Ref: Pavenhill Farm, Purton – PL/2026/04314

As requested, I can confirm that a full suite of amended architects' drawings, references **PURT-2604-02 to PURT-2604-11** (10 drawings in total), were issued on **18 September 2026**, together with an amended proposed **S278 Plan (Drawing No. 250814-LHC-SK-005 Rev B)**. These revisions were prepared in response to the highway comments received on **14 August 2026** (please see comments below).

AMENDED – Rev A

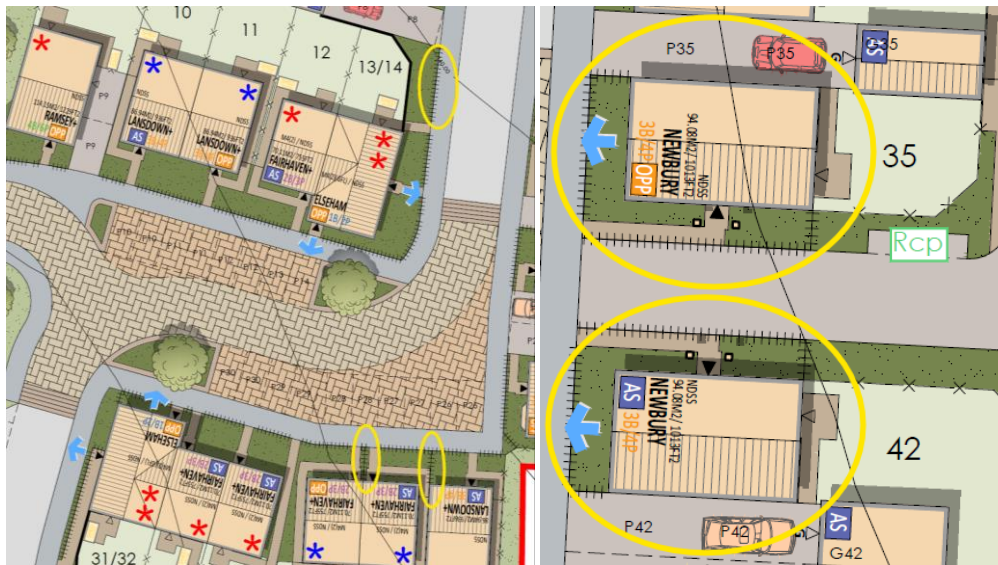
- The inclusion of a buffer zone to the above parking bays (Plots 10 to 14) and (Plots 26 to 30) to comply with Wiltshire parking standards

AMENDED – Rev A

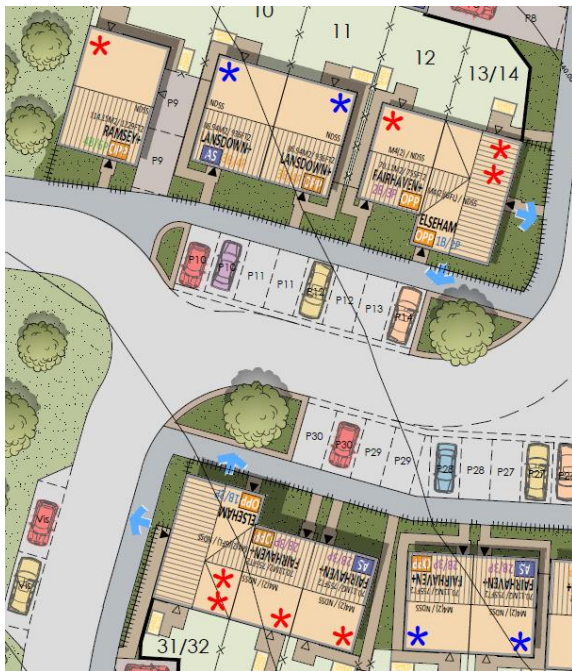
- The removal of the footpath around the turning head down to the visitor bay in front of Plot 9
- The extension of the footpath west to marry up with the existing PROW (PURT95) to provided increased active travel

- The removal of some initially proposed railings following further engineering advice and guidance (Plots 13/14, 26/27/28 and Plots 35 and 42)

AMENDED – Rev A

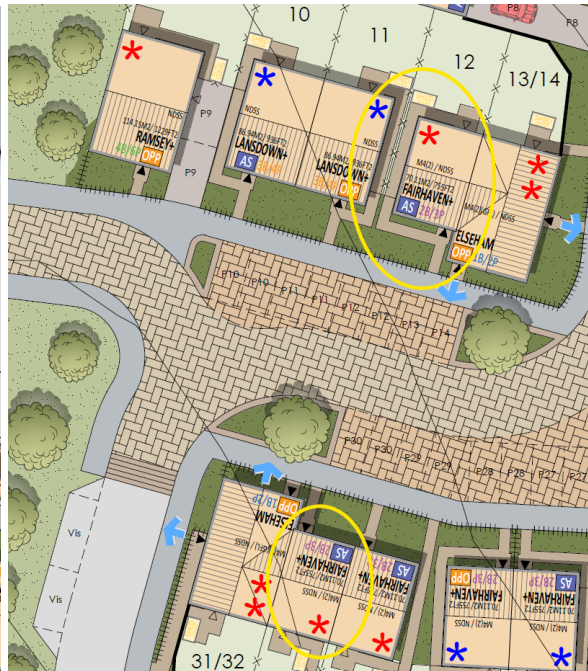
- Plot 12 and 30 have been handed the alternative way to improve access and construction detailing

AMENDED – Rev A

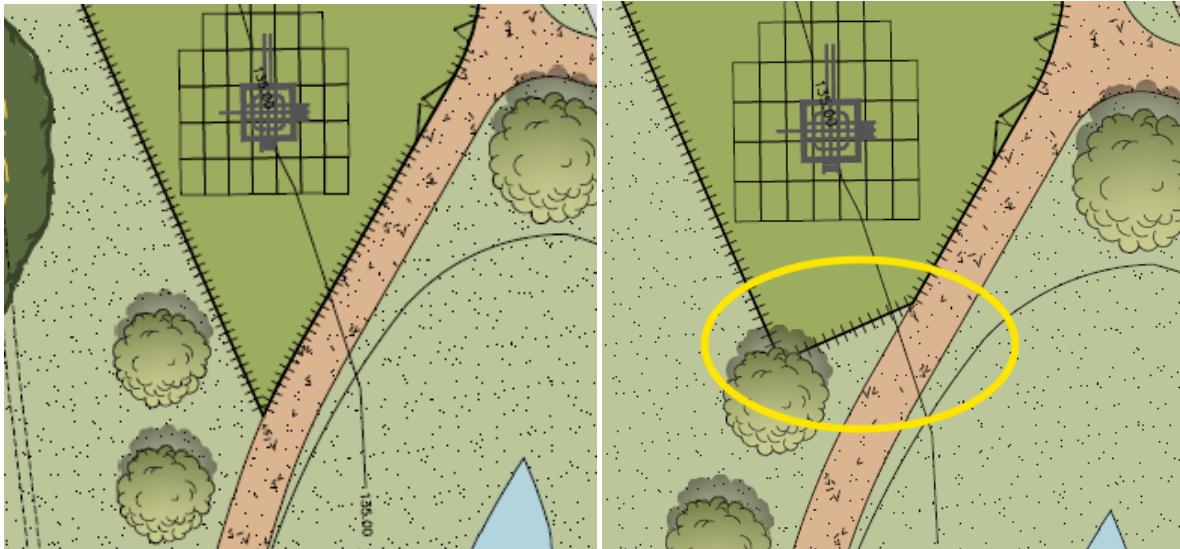
- Subtle realignment to proposed Play Area for aesthetic reasons solely

AMENDED – Rev A

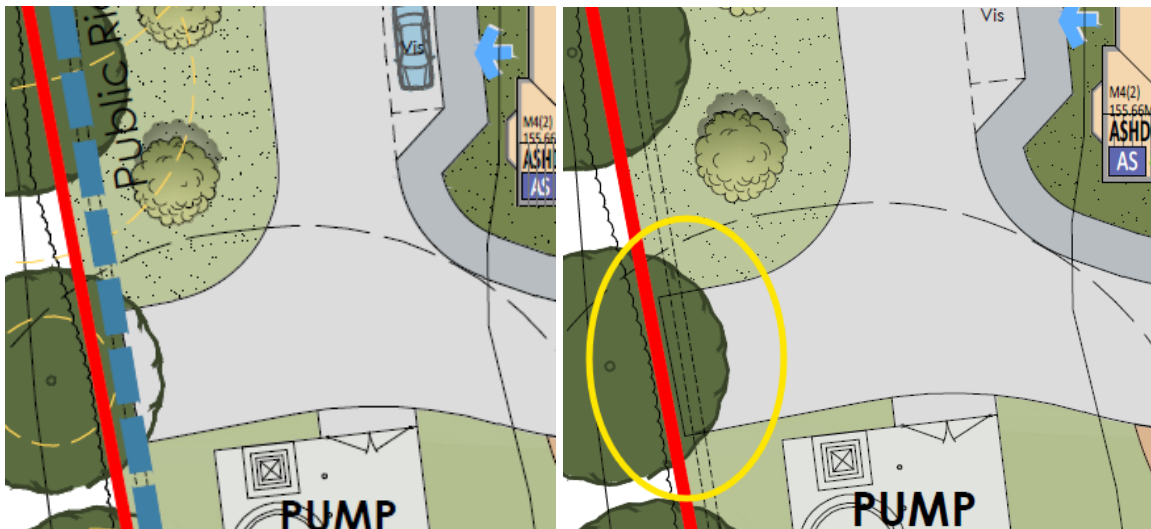
- Subtle realignment to proposed turning head in south section of site to provide clear, defined segregation from existing PROW PURT95

EV CHARGING & PARKING PLAN KEY

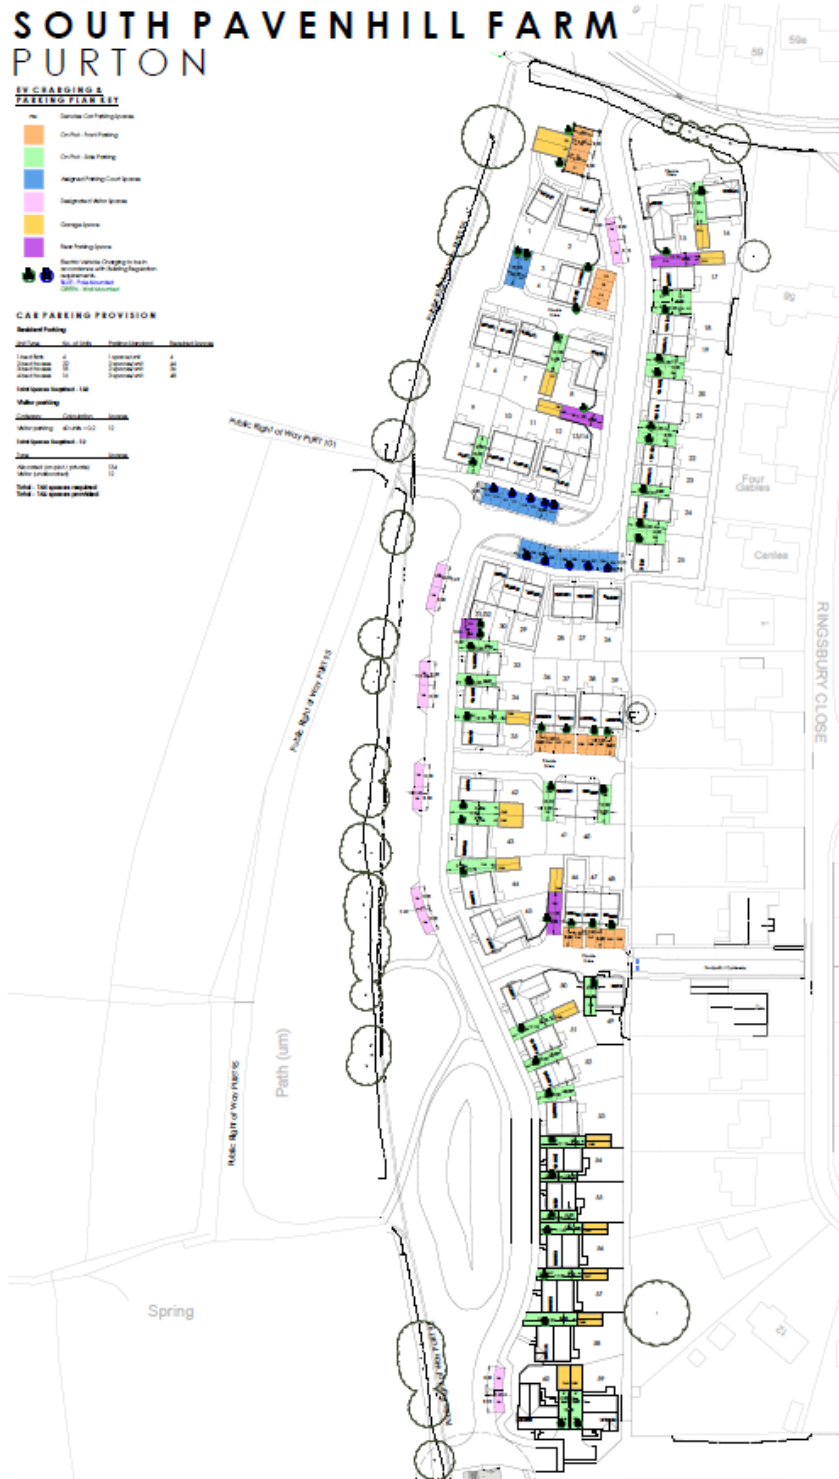
Car parking provision is adequate as a quantum of space provision. The latest revised car parking layout shows visitor spaces allocated within laybys and these spaces should all be 6m in length to allow for parallel parking manoeuvres. There is a slight drafting error where one of these designated visitor spaces is only 5m long.

Allocated parking for those plots without in-curtilage parking allocation should be a minimum of 2.5m by 5m to align with Wiltshire Council emerging parking standards as addressed in Local Transport Plan (LTN4).

- All parking spaces, including visitor bays have been annotated with dimensions to shown compliance on drawing PURT-26-04-10 Rev A and evidence compliance with Wiltshire parking standards
